Subject: Class 3 Permit Modification Request, Construction and Use of Hazardous Waste Disposal Units 11 and 12 for the Waste Isolation Pilot Plant Hazardous Waste Facility Permit Number: NM4890139088-TSDF

Class 3 Permit Modification Request

Construction and Use of Hazardous Waste Disposal Units 11 and 12

**Waste Isolation Pilot Plant
Carlsbad, New Mexico**

Figure B3-2
Repository Horizon

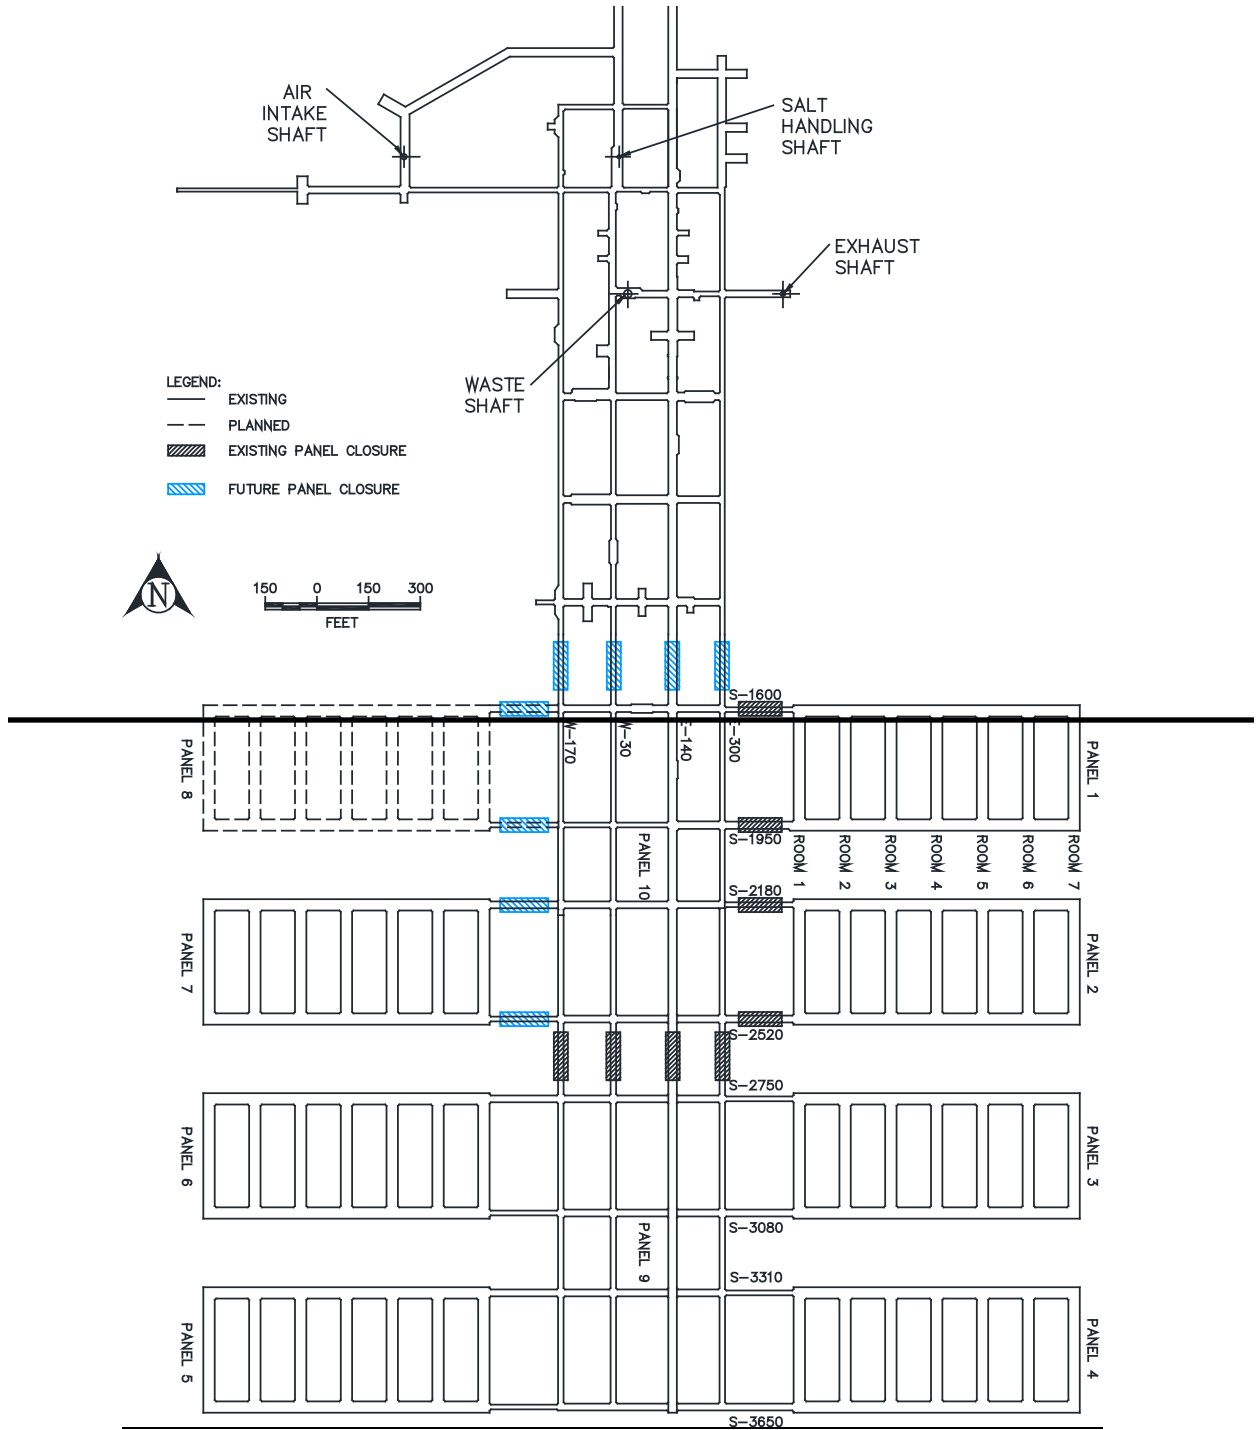
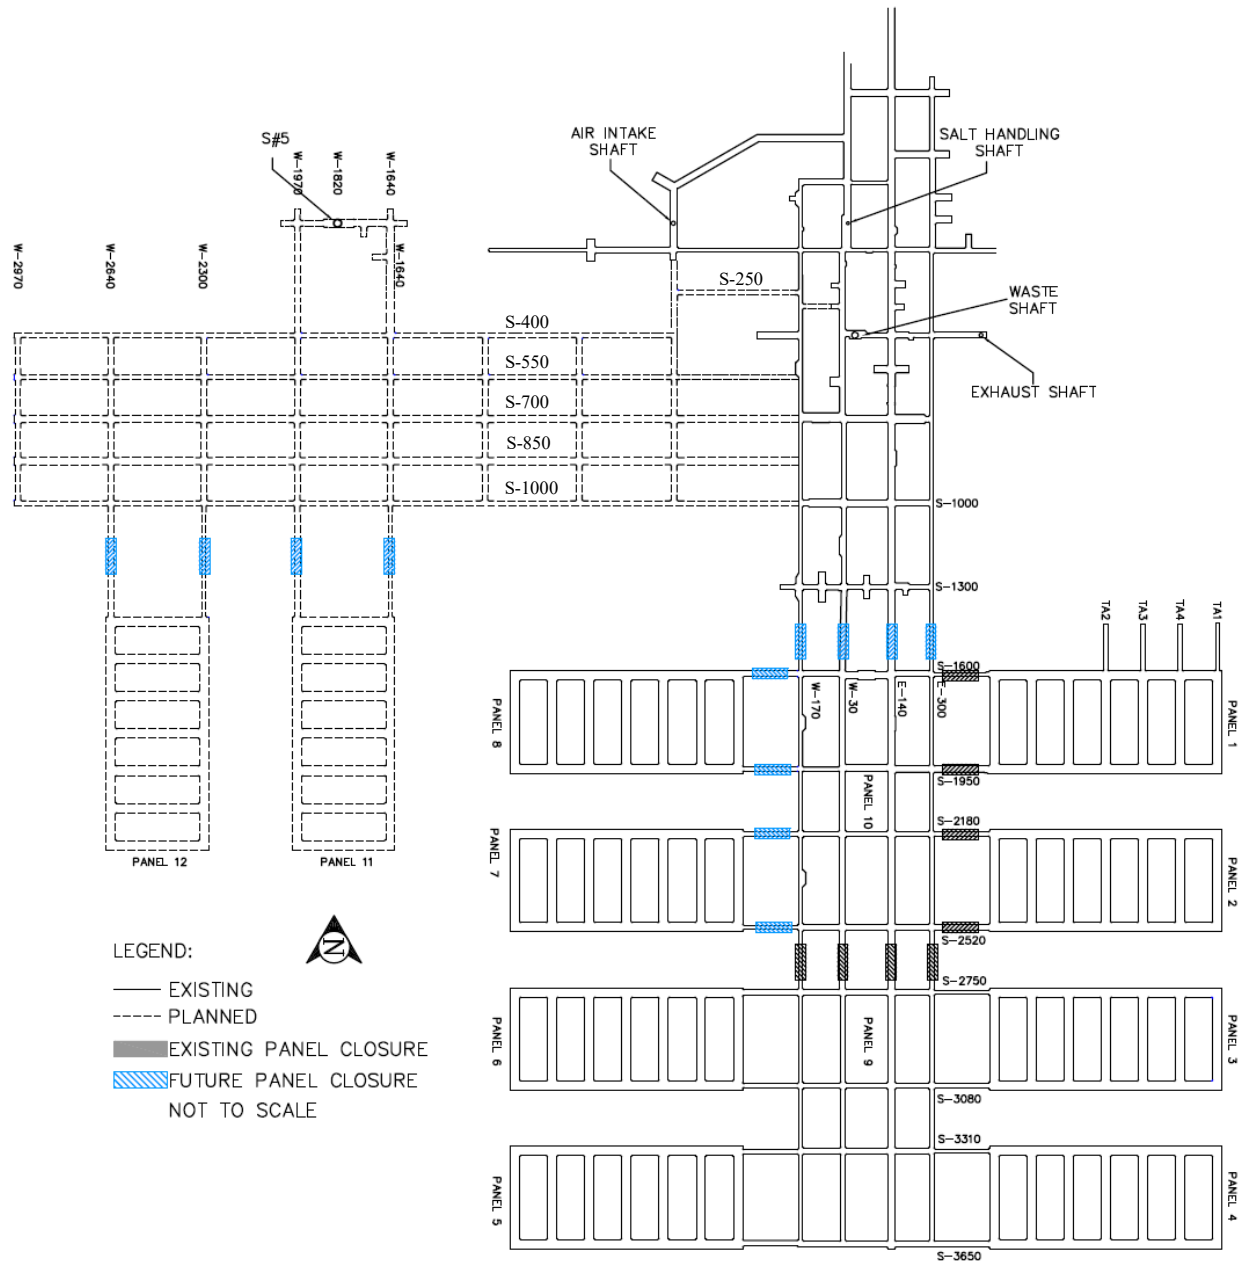
- Permit Attachment B, Appendix B3, Figure B3-2, *Repository Horizon*, is being modified to include the West Mains and Panels 11 and 12.

Figure D-2
Spatial View of the WIPP Facility

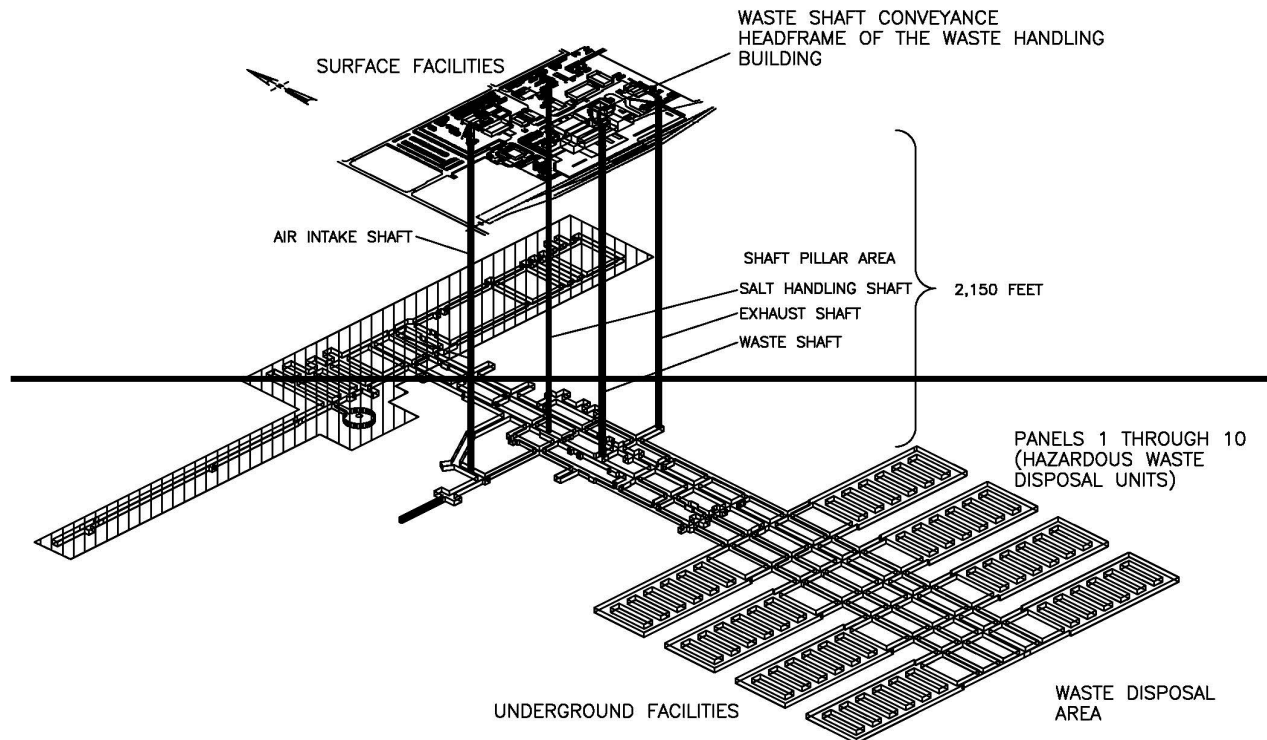
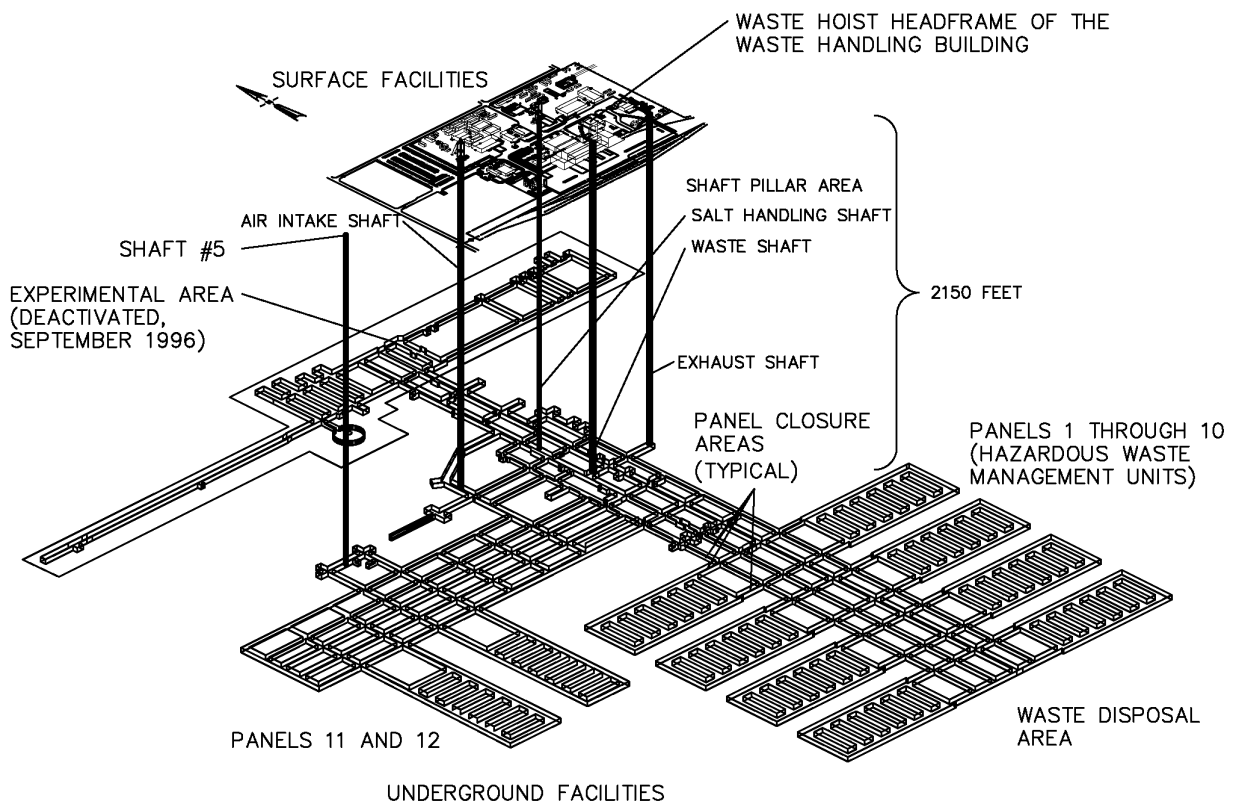
- Permit Attachment D, Figure D-2, *Spatial View of the WIPP*, is being modified to include the West Mains and Panels 11 and 12.
- Permit Attachment D, Figure D-3, *WIPP Underground Facilities*, is being modified to include the West Mains and Panels 11 and 12.

Attachment D, Figure D-2	Replaced figure to show the West Mains and Panels 11 and 12 in the spatial view of the WIPP facility.
Attachment D, Figure D-3	Replaced figure to show the West Mains and Panels 11 and 12 in the plan view of the underground facilities.
Attachment D, Figure D-7	Replaced figure to show the West Mains and Panels 11 and 12 in the underground assembly areas figure.

Figure D-7
Designated Underground Assembly Areas

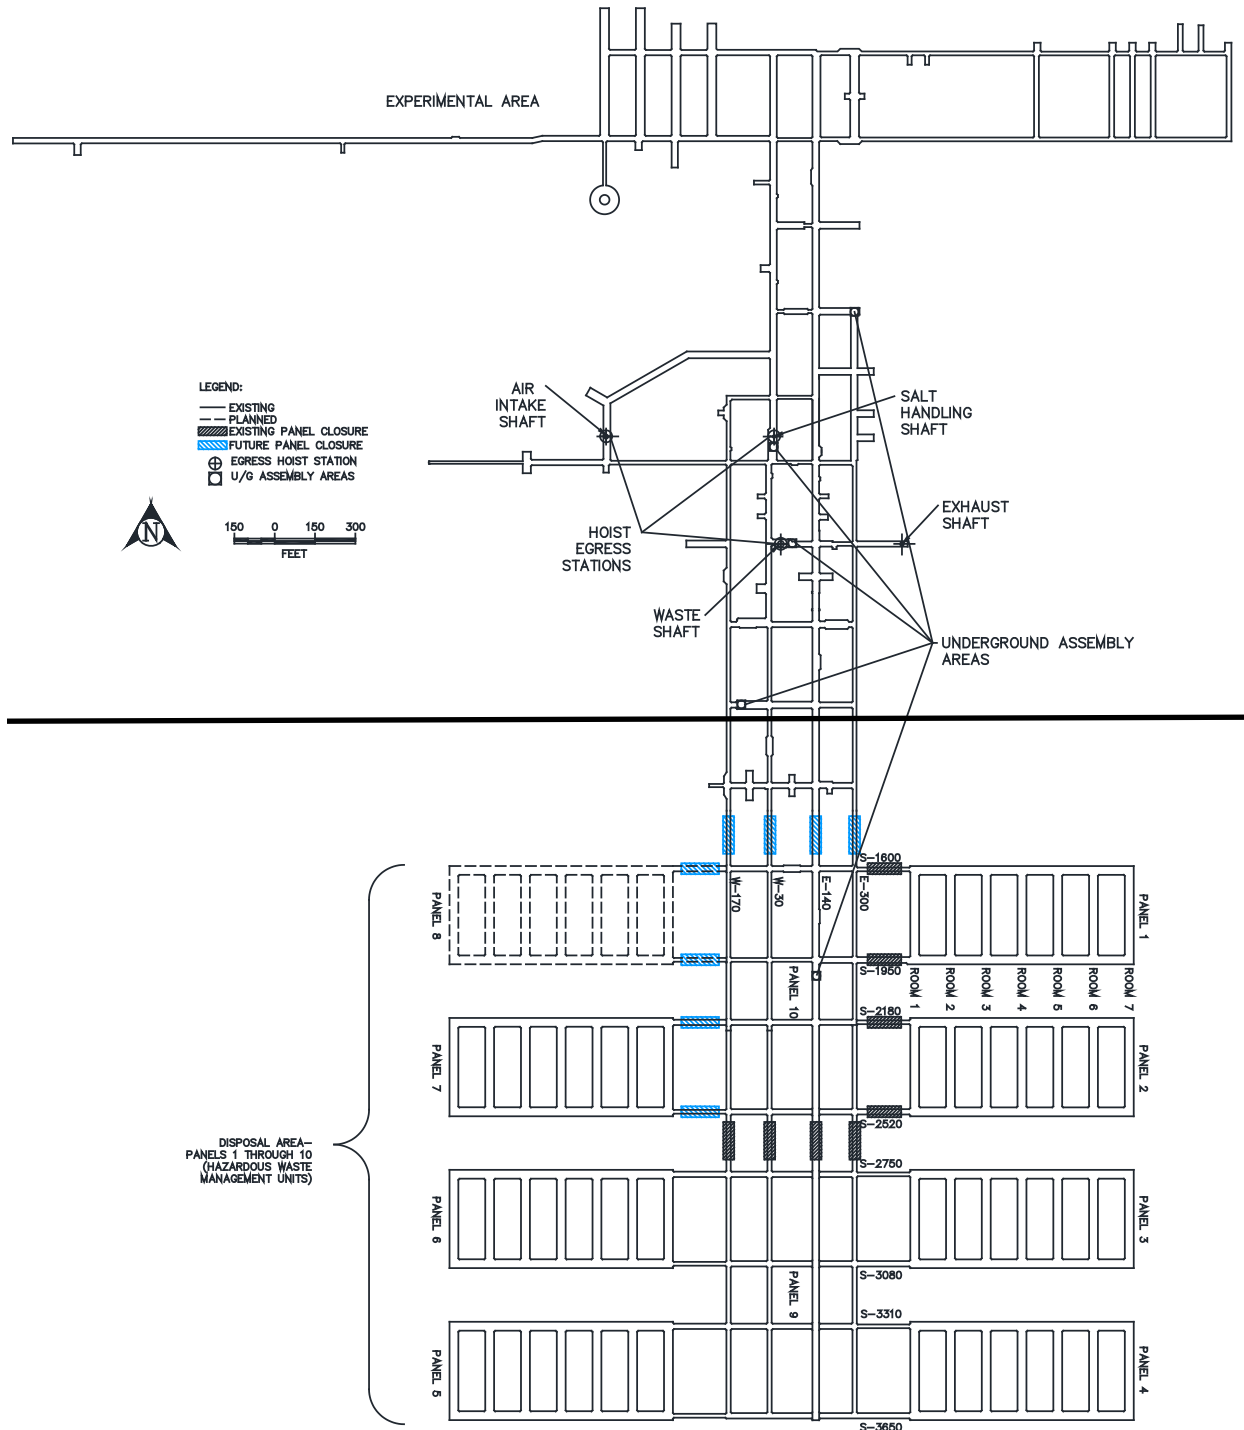
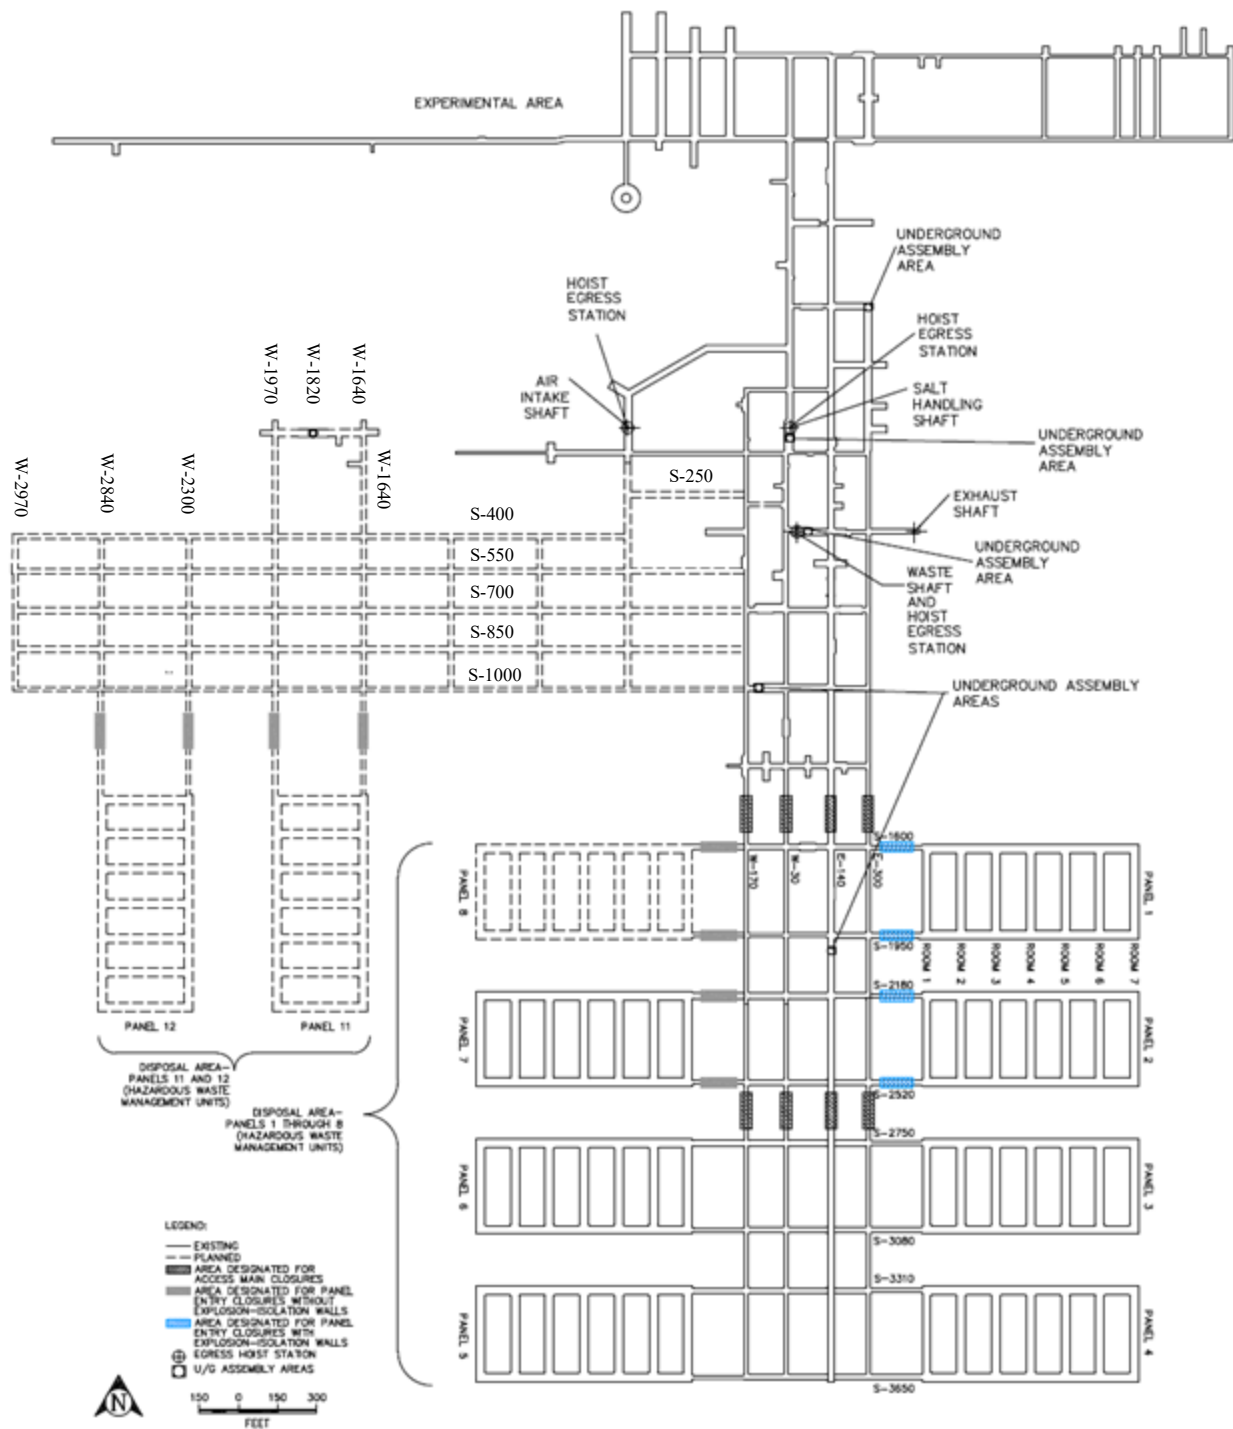
- Permit Attachment D, Figure D-7, *Designated Underground Assembly Areas*, is being modified to include the West Mains and Panels 11 and 12.
- Permit Attachment G, *Closure Plan*, is being modified to include Panels 11 and 12 in descriptive text where appropriate.

Attachment D, Figures	Modified Figure D-7, <i>Designated Underground Assembly Areas</i> , to show the planned underground repository layout with the West Mains and Panels 11 and 12. This modification is needed to accurately depict the planned underground repository layout.
